### COMMISSION ACTION FORM

# **<u>SUBJECT</u>**: PRELIMINARY PLAT FOR RINGGENBERG PARK SUBDIVISON $4^{TH}$ ADDITION

### ADDENDUM

Proposed Preliminary Plat Sheet P-3 – Other Sheets available on request

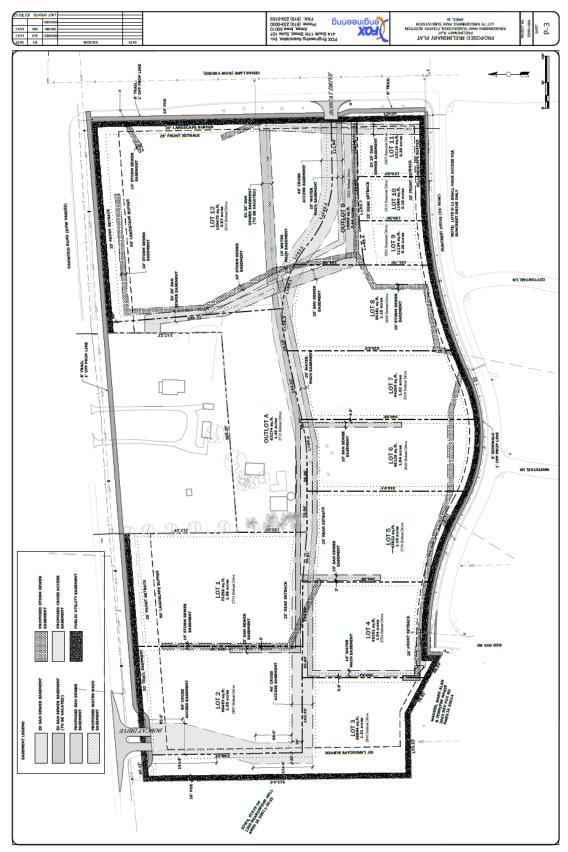
The Master Plan shows storm water detention areas within the landscape buffers that are required between distinctly different land uses. However, because of sloping grades along the entire north boundary of site and in some portions of the rest of the site perimeter, many of the landscape buffer plantings may be six to ten feet below the grade of the adjacent property. At the time of planting, the deciduous trees in the buffers will be 10 to 12 feet in height and the height of the conifers will be six feet. (See Landscape Plans that are part of the Major Site Development Plan) The sloping grades established by the Preliminary Plat design may reduce the effectiveness of the buffers to ensure compatibility between different building heights and use intensities. The grading can be adjusted and coordinated with the planting plan to raise the planting elevation and improve the effectiveness of the required landscape buffers. However, this may reduce the capacity of the storm water detention areas.

The revised Preliminary Plat and Master Plan is consistent with the Land Use Policy Plan, the proposed Master Plan, the Zoning Ordinance and the Subdivision Ordinance standards. However, the proposed grading on the north boundary may compromise the effectiveness of the landscape buffers. The landscape buffers on the north are especially important due to the size and height of the Independent Senior Living Facility. Staff also notes that the storm water detention areas exceed the City's standards by 80%.

Therefore, it is recommended that Alternative #1 be adopted. This is a recommendation that the City Council approve the Preliminary Plat for Ringgenberg Park Subdivision 4<sup>th</sup> Addition with the condition that the grading be modified to improve the effectiveness of the north landscape buffer.
